To: Cooper Bussmann Coiltronics® Customers
Subject: Product Change Notice (PCN) SD3118 Series of Low Profile Power Inductors

Effective December, 2009, Cooper Bussmann will implement the following dimensional changes to the SD3118 Series of Coiltronics® Low Profile Power Inductors:

New width, length and solder pad dimensions

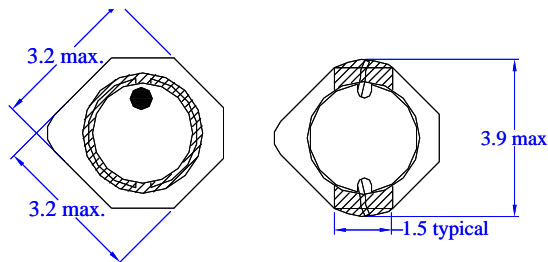
1. Width will increase from 3.1mm to 3.2mm maximum.
2. Length will increase from 3.7mm to 3.9mm maximum.
3. Solder pad width will increase from 1.2 to 1.5 typical.

There will be no changes made to the height or recommended pad layout.
